**CITY OF FLORENCE
PLANNING COMMISSION**

RESOLUTION PC 17 10 DR 01

A REQUEST FOR A DESIGN REVIEW PERMIT, to construct a new 2,596 square foot office building with accessory related storage/preparation area and related site improvements at Map #18-12-34-11, Tax Lot 03400 in the Mainstreet Area “B” District.

Site Plan

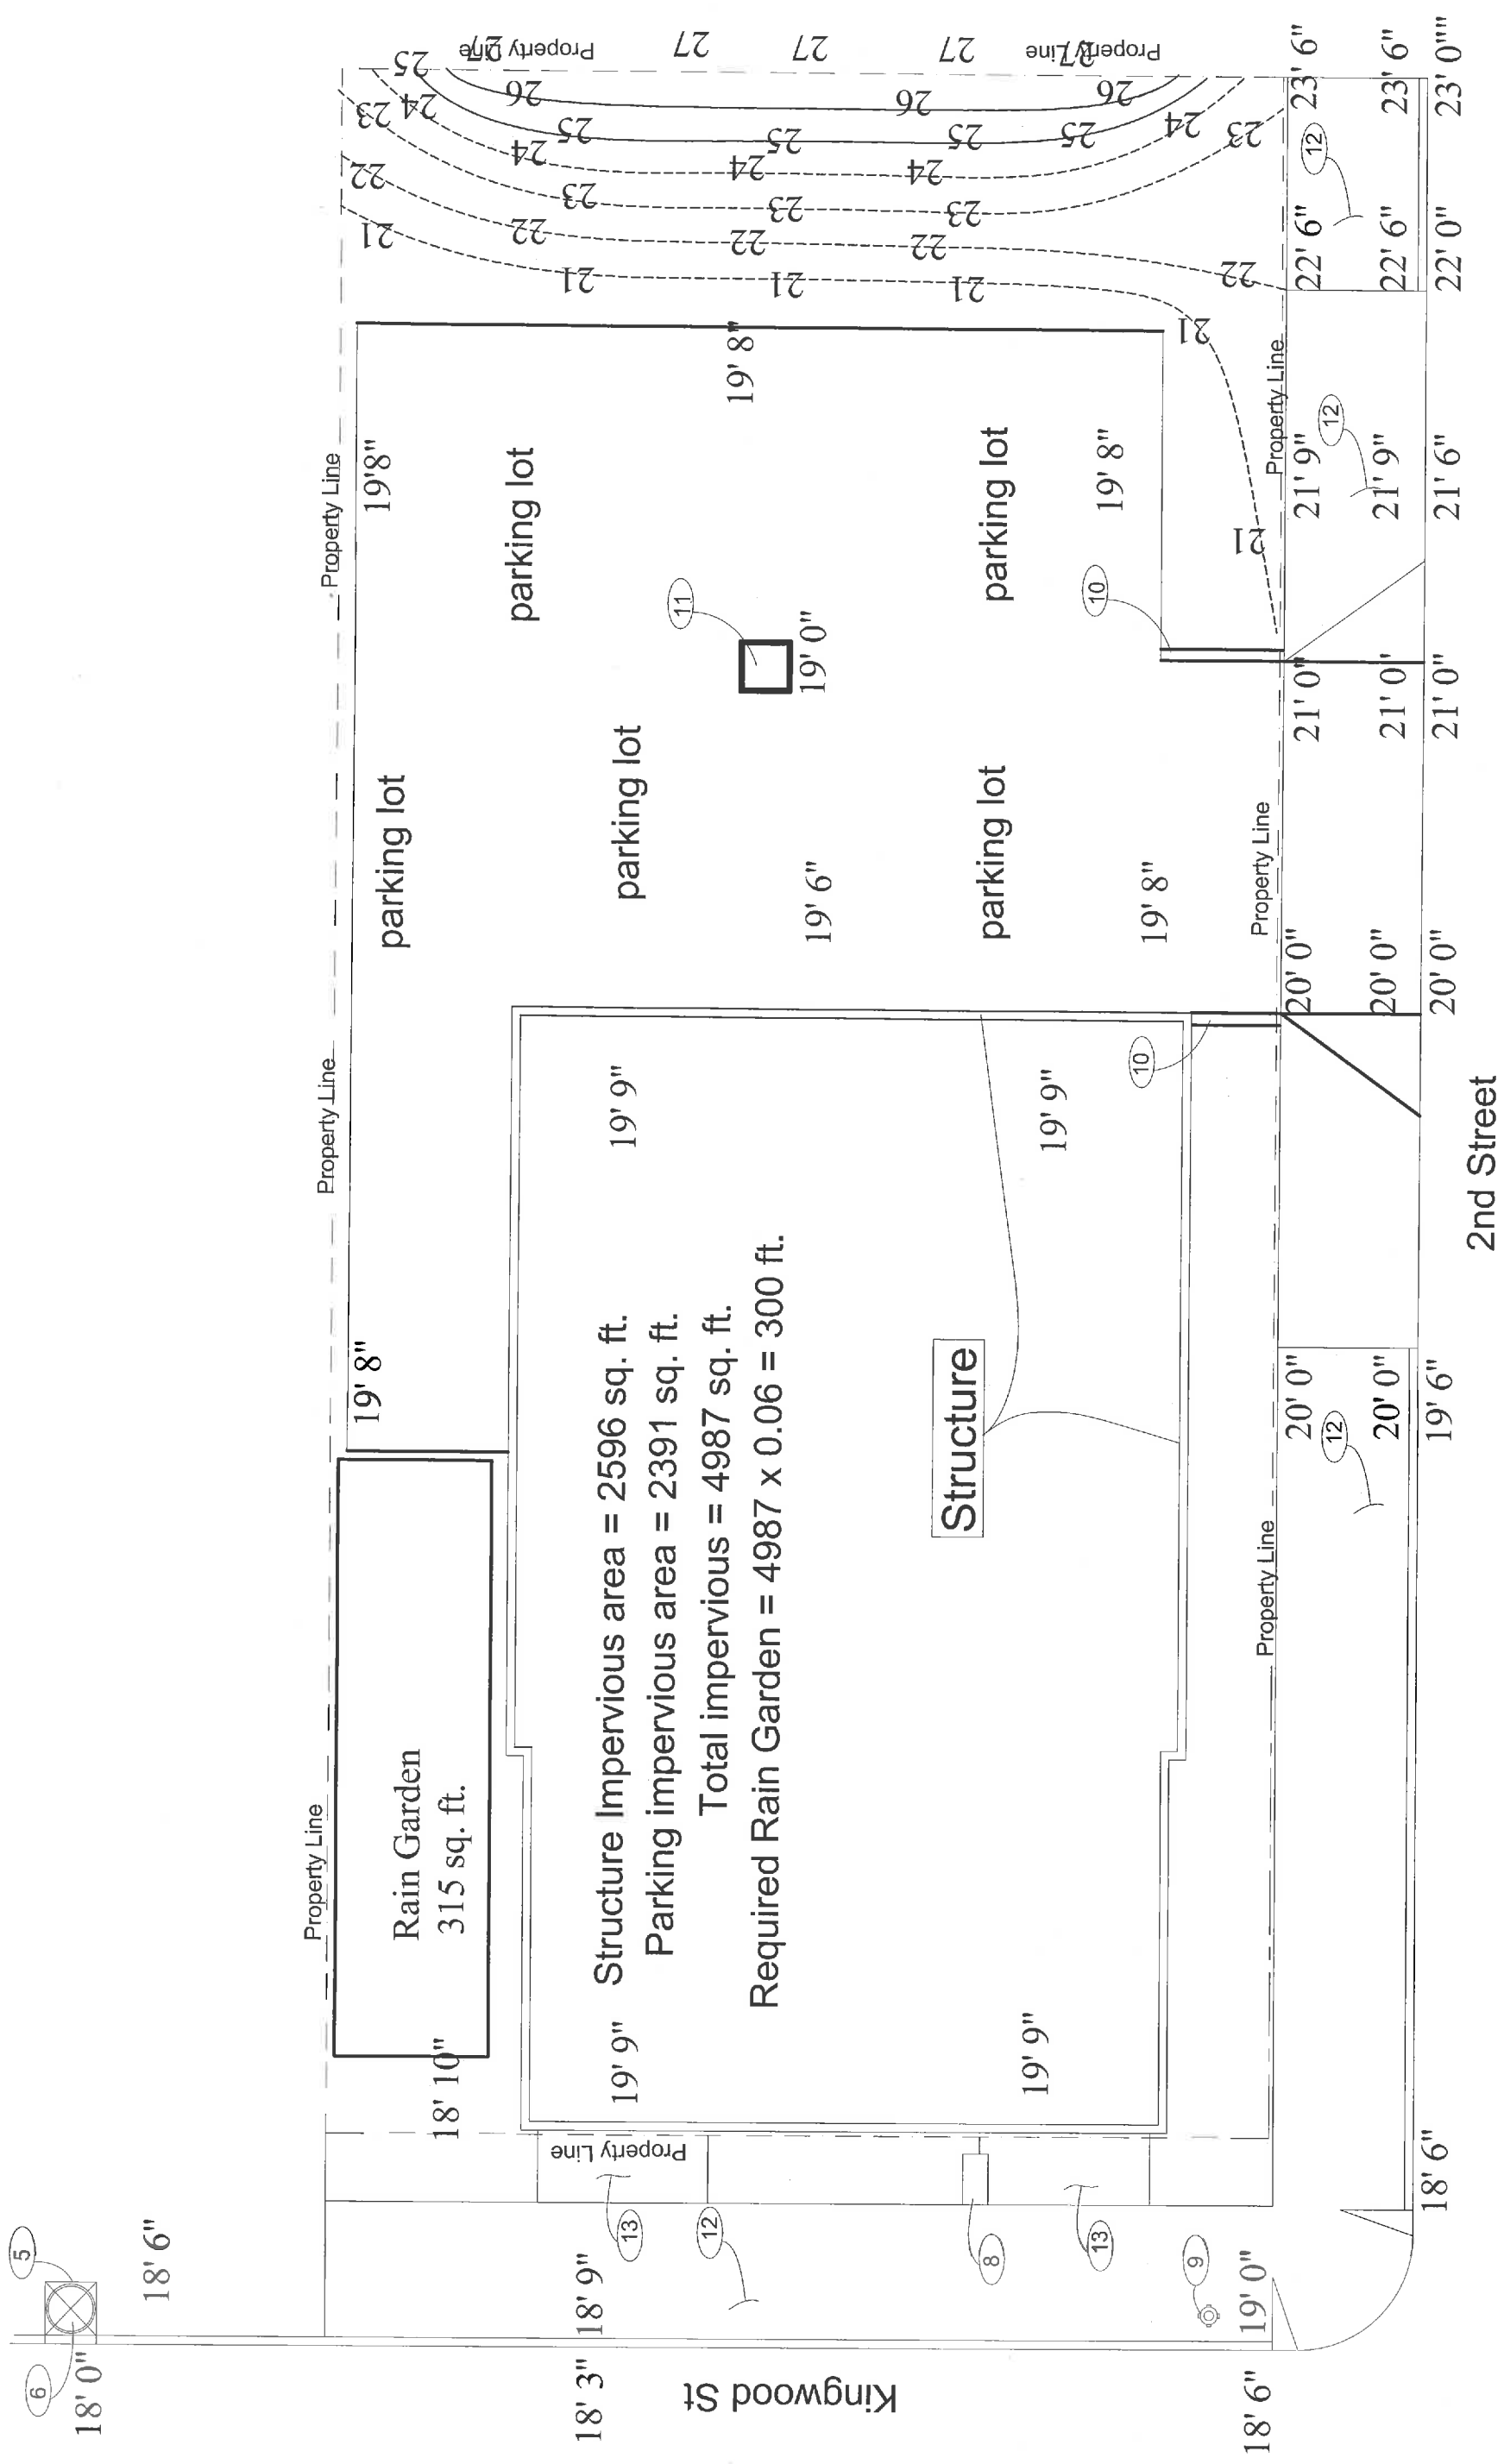
The landscape plan illustrates a 5' wide landscape area between the parking area and the 2nd St. right-of-way. Criterion 2 is met. The site plan appears to illustrate a curb along all edges of the parking lot and driveway with the exception of the northern property line, however curbing is not clearly indicated. The applicant also owns the adjacent property to the north and intends to develop this property in the near future.

The applicant has provided a parking plan which demonstrates parking spaces in a variety of widths from 9'6" to 13' in width. The parking does not meet the requirements of FCC 10-3-9.

The applicant has indicated that they will provide an aisle width 21 feet wide. An additional 2' of width is needed in order to meet the minimum aisle width for 90° parking and additional space is needed for bollards at the corners of the proposed building in order to prevent damage by vehicles.

The applicant shall provide, as part of the previously stated conditions, a revised parking plan which meets the requirements of FCC 10-3-9. **(Condition 4.4)**

The applicant shall provide parking spaces which measure 9'6" in width by 19' in length. **(Condition 4.5)**

The applicant shall provide 4" wide striping for parking spaces double-line striped, two feet on center. **(Condition 4.6)**

The applicant shall provide an additional width (at minimum one foot) for bollard

The applicant shall provide at least two bicycle parking spaces meeting the minimum size, location, design, and other requirements listed in FCC 10-3-10. Bicycle parking shall be indicated on the required revised parking plan. **(Condition 4.8)**

LANDSCAPE DESIGN
 KINGWOOD ENGINEERING OFFICE
 374 KINGWOOD FLORENCE OR
 DESIGN BY LISA WALTER-SEDLACEK
 LAUREL BAY GARDENS

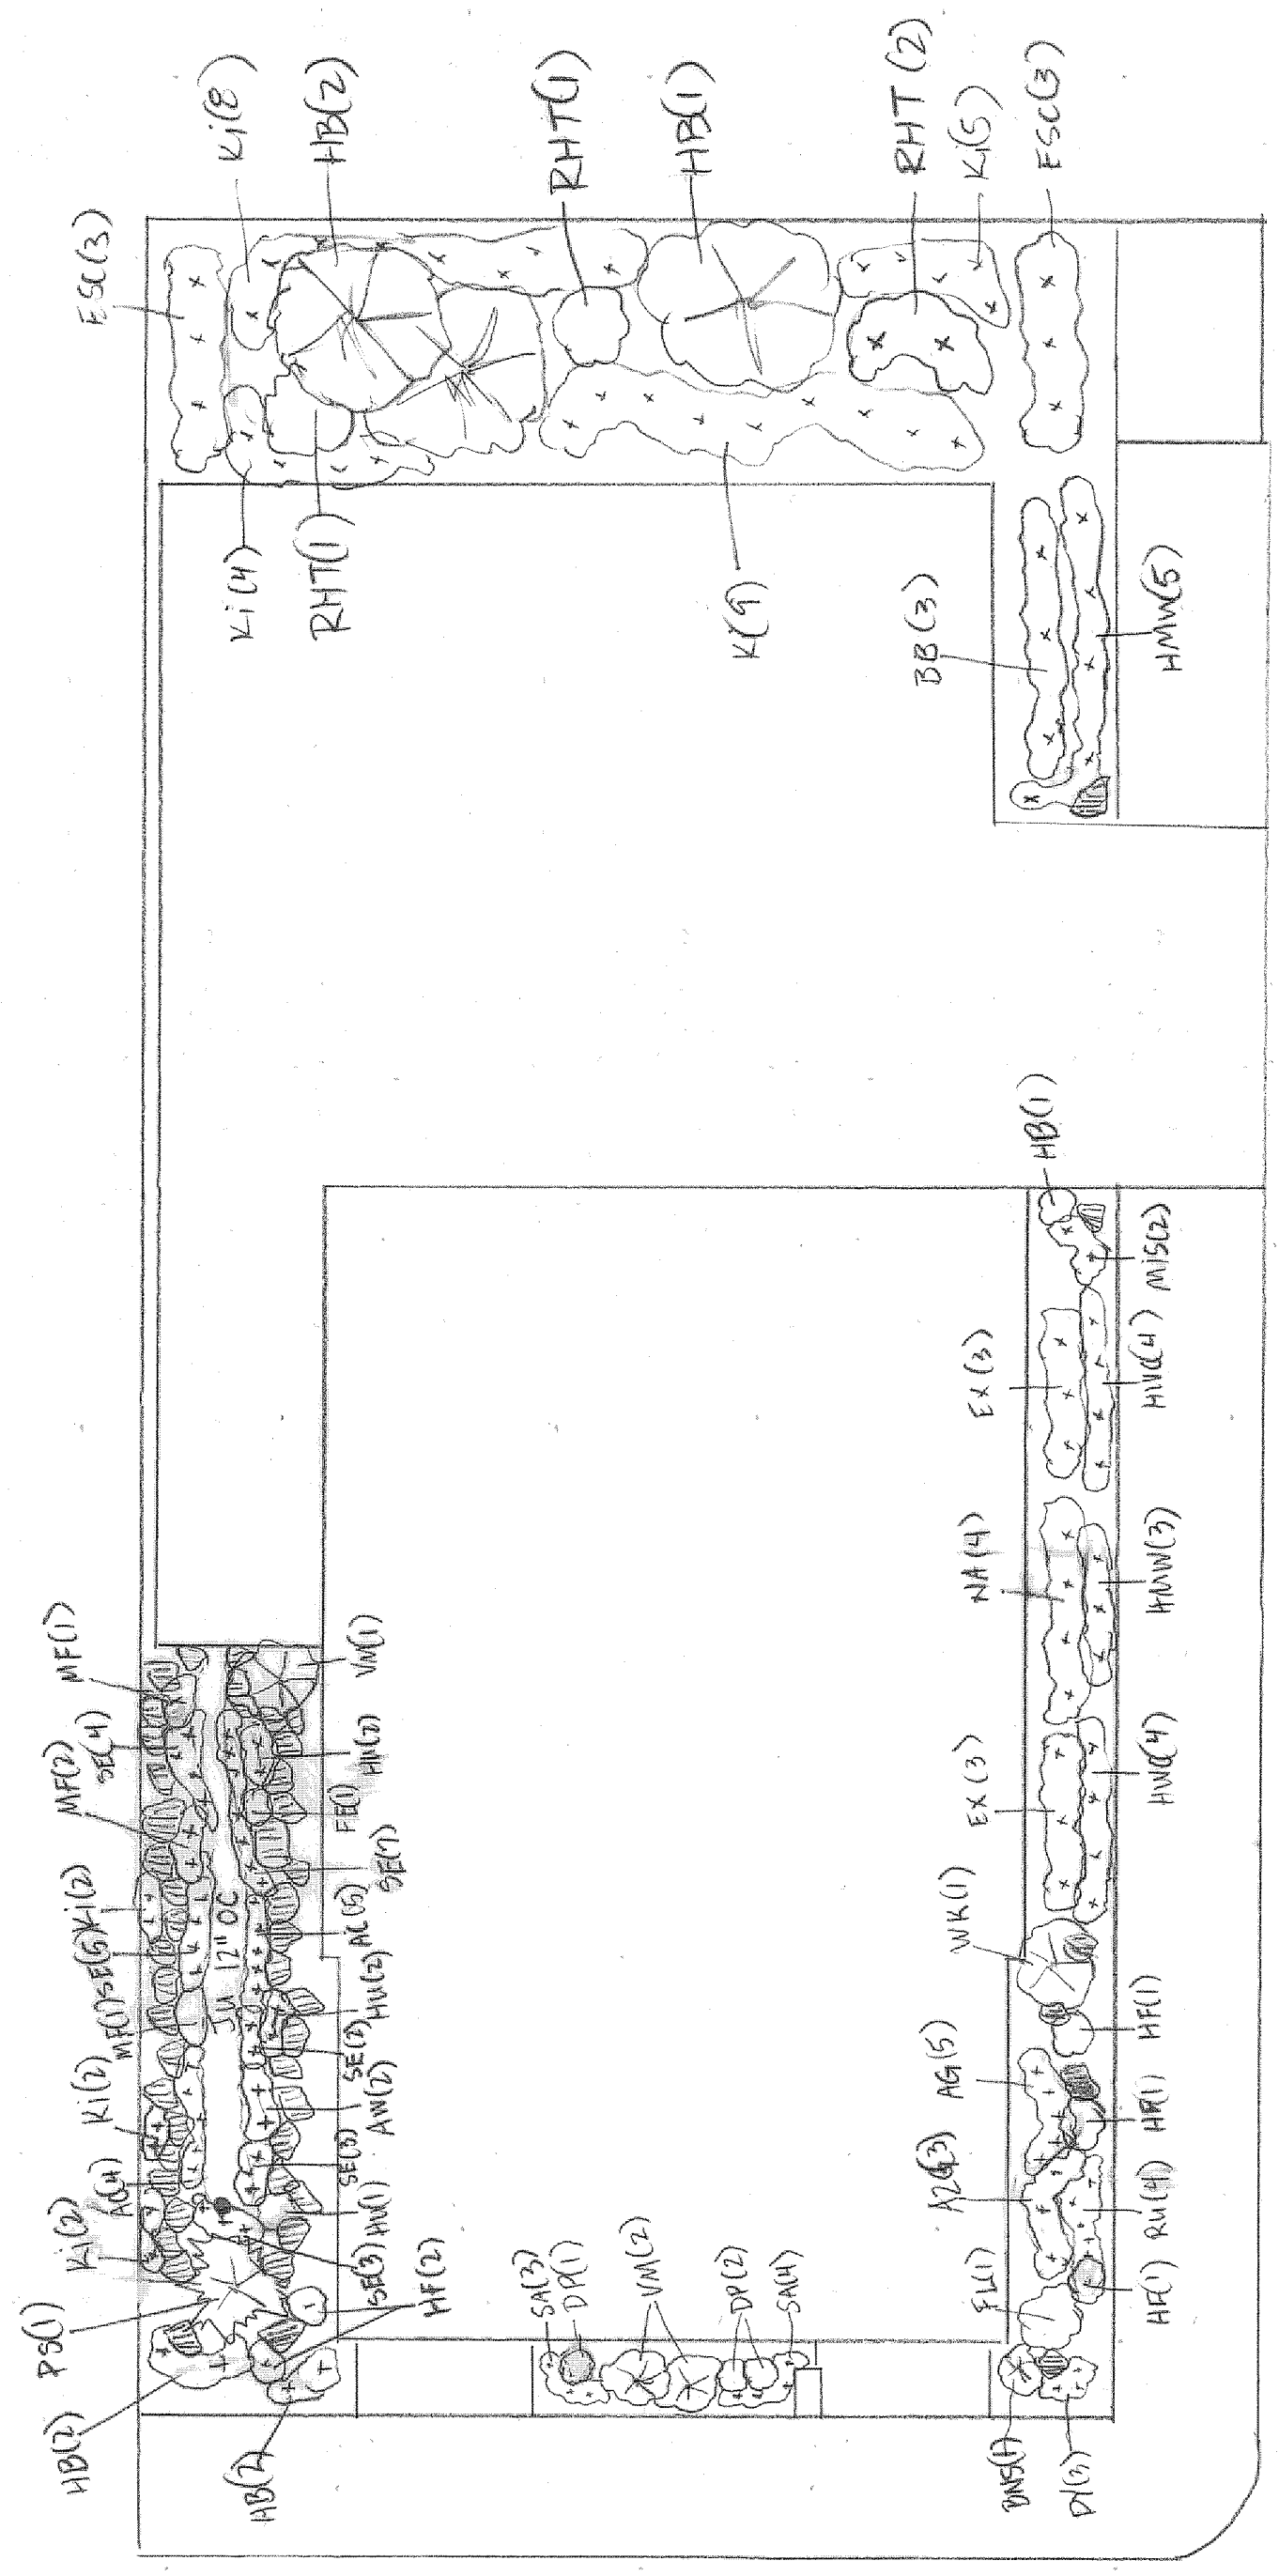
The site has 177 lineal feet of street frontage according to the provided site plan. Per this distance, according to current code, six trees are required on the site.

The site, as proposed, will have three Jaquemonti Birch trees and one Weeping Katsura which, while not listed in the Tree and Plant List for the City of Florence, will meet the intent of the landscaping code.

The proposed Blue Spruce and Vine Maples (3) will not meet the intent of the landscaping code (see Note 1 – “Tree and Plant List for the City of Florence” for Vine Maples and size requirements for other Spruce specimens).

The applicant shall select two additional trees which meet the minimum standards of the Tree and Plant List for the City of Florence and submit a revised landscaping plan (or may substitute for the trees which do not meet the criteria). **(Condition 7.1)**
